## Product Change Notice (PCN)

**PCN Number:** PCN-0451321R-01

**Product(s) Affected:** PDP-40

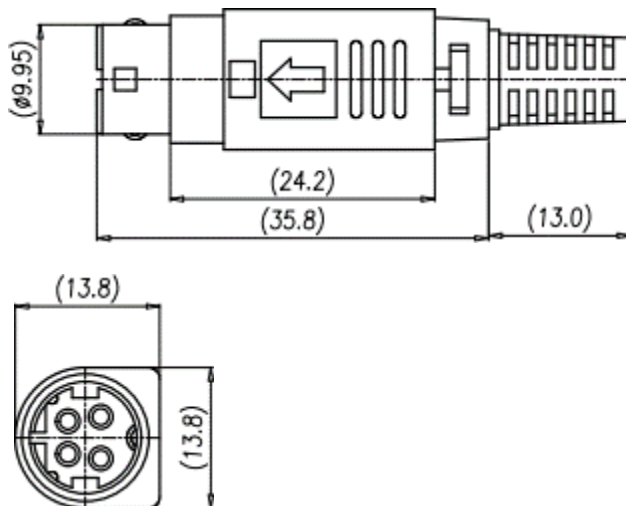
**Reason(s) for Change:** manufacturing build location change.

**Description of Change:** housing and materials changes as shown below.

**Old design materials**

MATERIAL	PLATING
OUTER HOOD	ABS	
METAL SLEEVE	Brass	Nickel
CLAMP	Brass	Nickel
PIN/BODY	Brass/PBT	Silver
PLASTIC RING	POM	
METAL COVER	Brass	Nickel
SPRING	Steel	
INNER HOOD	ABS	
STRAIN RELIEF	PVC

**New design materials**

MATERIAL	PLATING
housing	PBT (UL94V-0)	
contacts	copper alloy	silver
plastic cover	ABS	
metal shell	copper alloy	nickel
metal cap	copper alloy	nickel
cable fixer	copper alloy	tin
ring	POM	
spring	steel	nickel
plastic tube	ABS	
SR	PVC
